Service Bulletin

Bulletin No SM-08-006-00

| Model | Model Code | Year Model | Issue Date |
|----------|---------------|------------|------------|
| CIVIC 5D | FK1, FK2, FK3 | 12 | 18-05-12 |

Wind Noise From Door Mirror Area

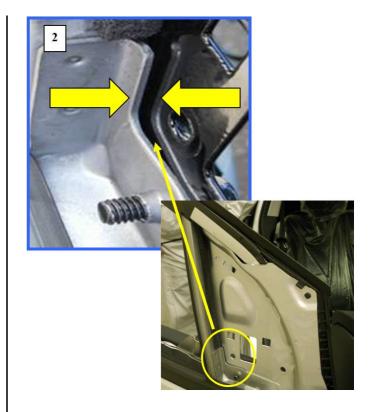
1. The Run channel sash foam has gaps, or is missing.

Run Channel sash foam gap or missing (A).

- 1. Remove the door mirror as described in MaRIS.
- 2. Remove all visible foam, be careful not to damage painted surfaces, or trim.
- 3. Degrease the Run Channel sash and bracket.
- 4. Apply a new piece of foam cut to the dimensions shown below to area A.
- 4. Ensure that the foam covers both the run channel sash and the mirror patch.

Use part number 06990-SA5-000 foam or equivalent foam with a maximum thickness of 4mm.

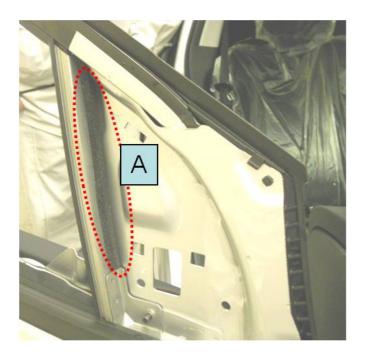
2. Run channel sash bracket gap has excessive clearance at the mirror fixing point.

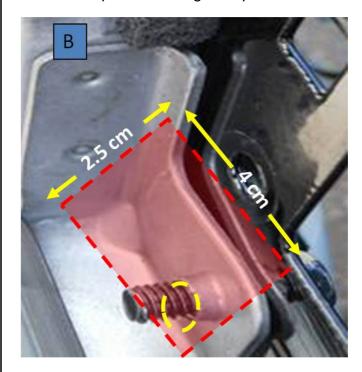
Run channel sash bracket gap (B)

Area of concern is at the Mirror base (C) shown below.

- 1. Remove the door mirror as decribed in MaRIS.
- 2. Degrease the Run Channel sash and bracket.
- 3. Apply a new piece of foam cut to the dimensions shown below to area B.
- 4. Make sure to cut a hole so that the door mirror stud passes through the patch.

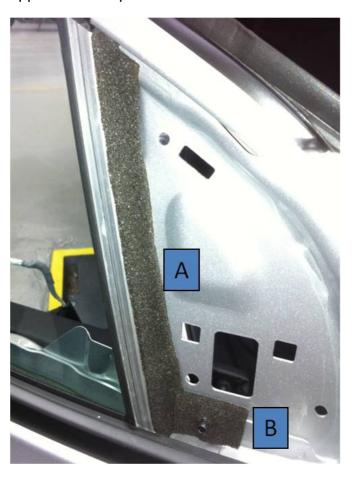
Below shows the completed repair to the Run channel sash and sash bracket with the foam applied to both points A and B.

Re-fit door mirror as described in MARIS. Test Drive the vehicle to ensure that the noise has been eliminated.
